PLANNING BOARD REPORT

Yarmouth Elementary School Fifth Grade Playground and Community Garden

Special Exception and Major Site Plan

Date: February 3, 2022, Planning Board Meeting Date: February 9, 2022

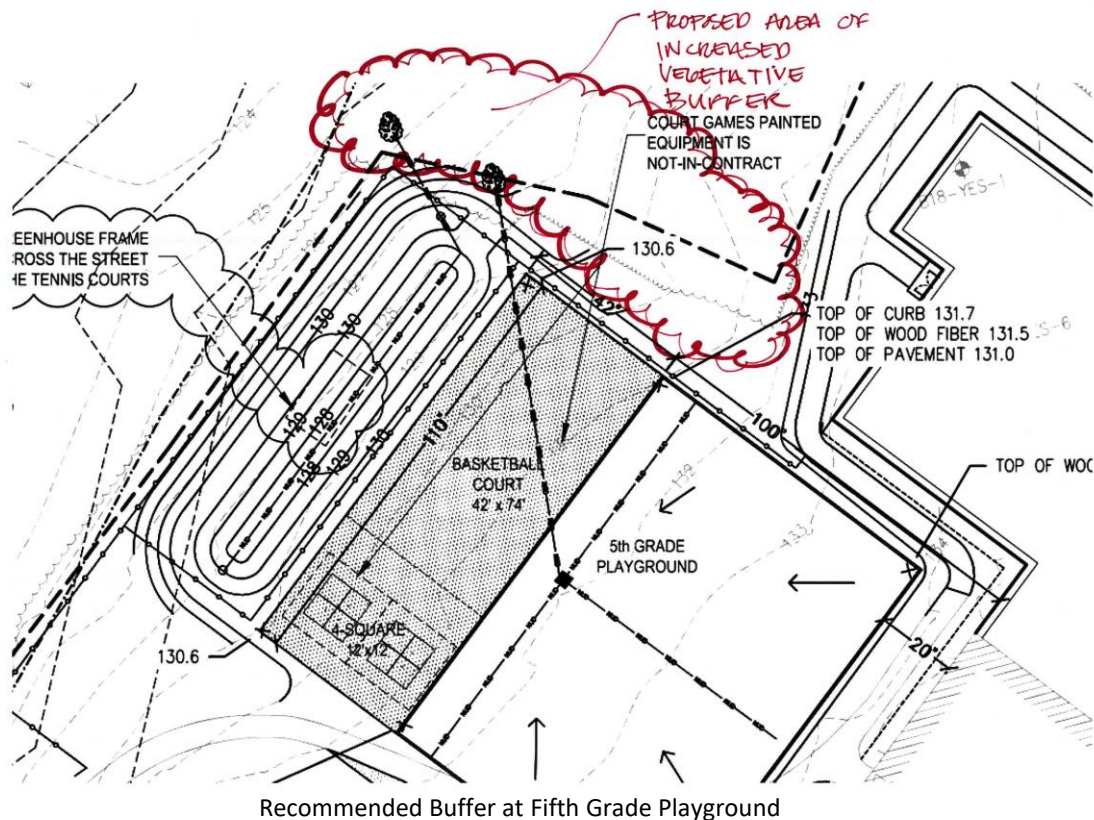
Buffering between the expanded elementary school and the neighbors on Tenney Street is an important site plan element. As part of the 2019 approval, a landscaped buffer was proposed around the northeast corner of the expanded building. Although the playground was not contemplated at the time of the 2019 approval, it may be prudent to expand the proposed buffer around the edge of the playground.

Trees need to be removed to accommodate the relocated community garden, and it is recommended that new trees be planted around the playground to account for the removal in the garden as shown below.

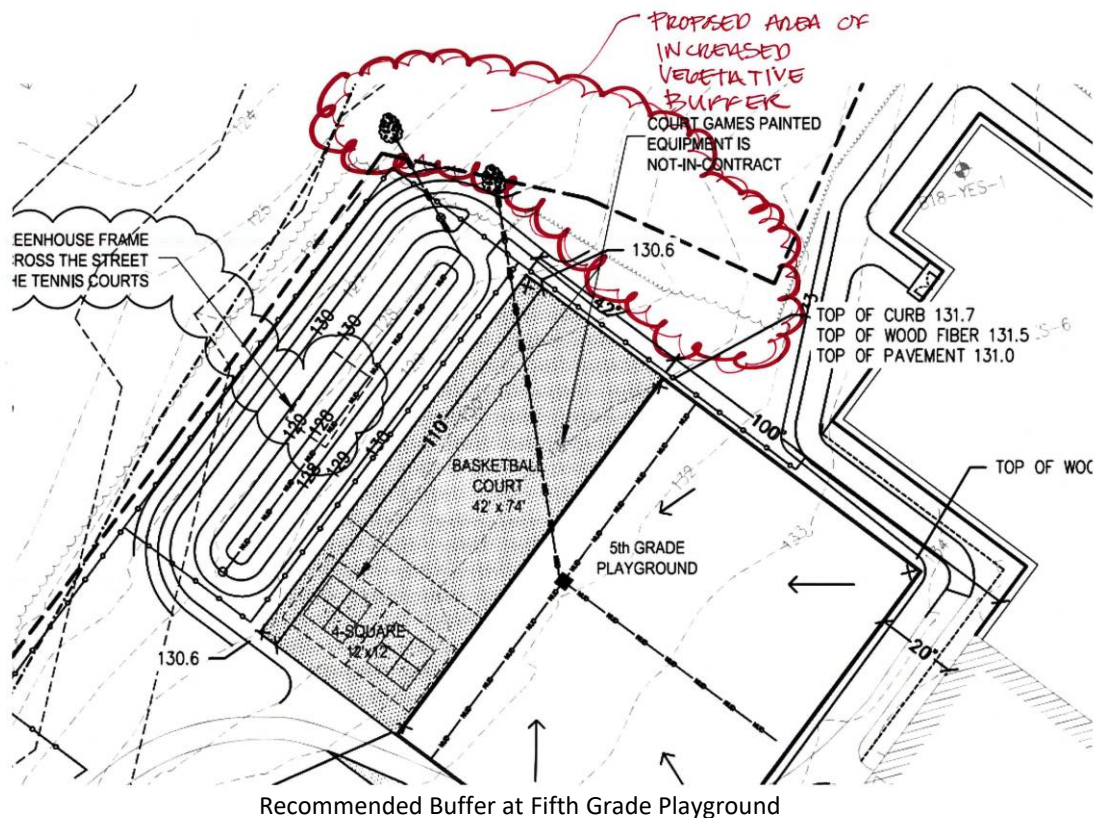
Buffering between the expanded elementary school and the neighbors on Tenney Street is an important site plan element. As part of the 2019 approval, a landscaped buffer was proposed around the northeast corner of the expanded building. Although the playground was not contemplated at the time of the 2019 approval, it may be prudent to expand the proposed buffer around the edge of the playground.

Trees need to be removed to accommodate the relocated community garden, and it is recommended that new trees be planted around the playground to account for the removal in the garden as shown below.
